Author response to Referee #2 (RC2)

Radiative Constraints on VIIRS Nighttime Detectability of Lower-Tropospheric Methane
(egusphere-2026-4225)

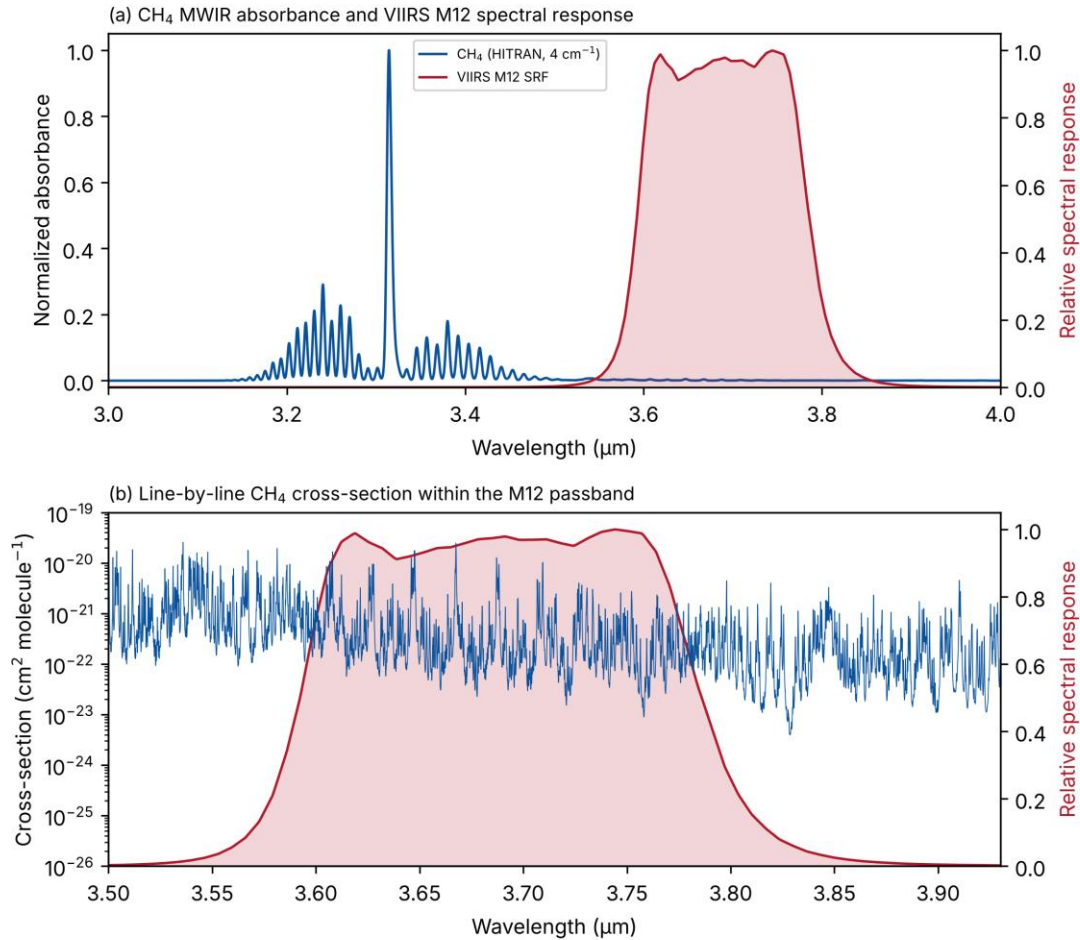
More detail is needed on the absorption/emission spectra in the MWIR. The specific structure

is referenced throughout “... VIIRS M12 band, which has a small overlap with the wing of methane’s MWIR absorption feature”. Pulling HITRAN and plotting spectral absorption along with the spectral response of the instrument would be a helpful thing to refer back to throughout the paper. Also, there is more than one MWIR band in VIIRS and I’m assuming M12 (3.61-3.79 μ m) is the one that spans the strongest absorption feature but that needs to be shown explicitly? After all, there is a channel that spans very close to that range that is much higher resolution (I4: 3.55-3.93 μ m – 375m resolution versus 750m for M12). Also, I didn’t see a mention of M12’s spectral range (just a note its centered around 3.7 μ m) – that needs to be in there somewhere, preferably via plotting the spectral response.

Author response: We thank the referee. We added the M12 spectral range (3.61 to 3.79 μ m) to the Introduction and added a new Figure 1 with HITRAN2024 methane absorption plotted against the NOAA-21 M12 relative spectral response. Panel (a) spans 3.0 to 4.0 μ m and shows that M12 does not span the strongest absorption feature; it overlaps only the weak long-wavelength wing of the 3.3 μ m band, where the response-weighted mean normalized absorbance is about 0.1% of the maximum. This is the premise of the hypothesis tested. Panel (b) shows the line-by-line cross-section from 3.5 to 3.9 μ m. On I4: we selected M12 because it has lower noise on NOAA-21; at a typical scene temperature of 270 K the NEdT is 0.158 K for M12 and 0.416 K for I4 (Wang et al., 2024), which outweighs the finer 375 m resolution for a detection-limited problem. The statement is now in Sect. 1.5.

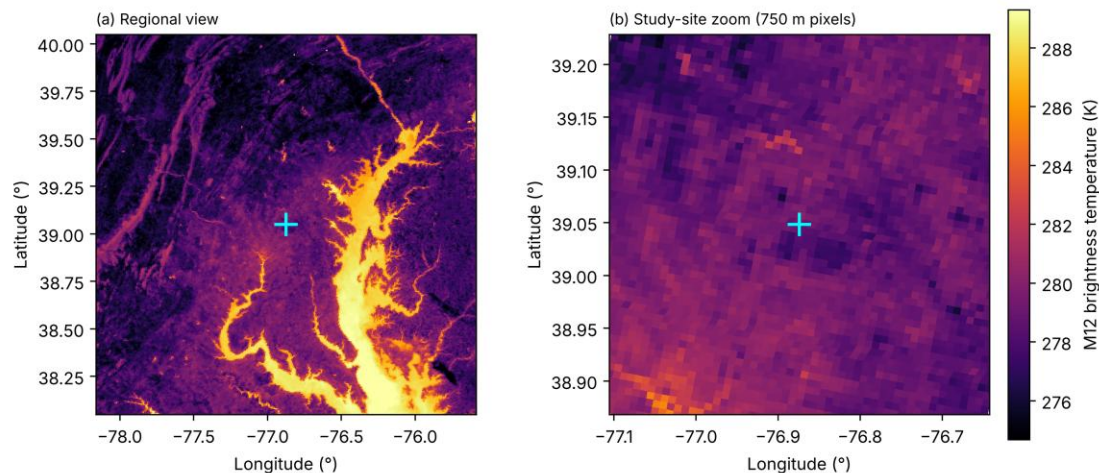
An overall weakness of the study is a lack of observational grounding. I get that it's a theoretical paper, and so a real data processing effort would be out of scope but I think even showing an image of VIIRS in the MWIR over HUBC would be helpful to ground things.

Author response: We agree and added a new Figure 2 showing the NOAA-21 VIIRS M12 brightness temperature for the 19 October 2023 nighttime overpass, with the study site marked. Panel (a) is a regional view and panel (b) an enlarged view with native 750 m pixels. The site pixel is 279.39 K. A full observational detection analysis is outside the scope of this theoretical study.

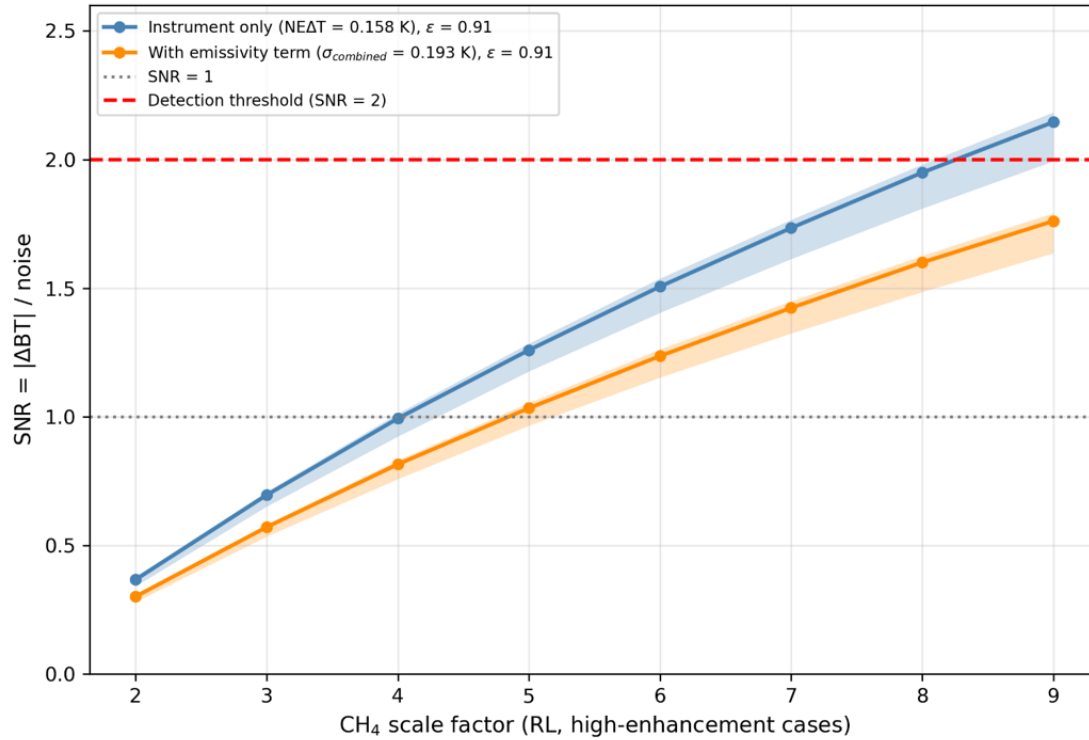
I'd put a plot of SNR vs CH₄ scale factor somewhere, with a horizontal line at 1 to show just how far away we are from detection. Just a suggestion though, maybe plot it and see how it looks. A comment in the captions of Figure 4 and 5 restating the NETD goal you're trying to reach would also be welcome, to drive home the point that those plots are nowhere even close.

Author response: We thank the referee and added the plot as new Figure 8. It shows residual-layer SNR versus CH₄ scale factor (2x to 9x) for the instrument-only noise floor (NEdT = 0.158 K) and for the operational noise floor including surface-emissivity variability (sigma_combined = 0.193 K, 3x3 window). Lines show the CAMEL-matched emissivity (0.91) and shading spans emissivities 0.89 to 0.99. A dotted line marks SNR = 1 and a dashed line marks the SNR = 2 detection threshold. With the emissivity term included, no case reaches SNR = 2 (maximum 1.79). Regarding restating the NEdT goal in the captions of the NBL and RL figures (now Figures 5 and 6): the NEdT of 0.158 K and the SNR ≥ 2 criterion are stated in Sect. 1.5 (L. 206-212) and Sect. 2.2 (L. 250-252), and Figure 8 shows the distance to the detection goal directly, so those two figures are left unchanged.
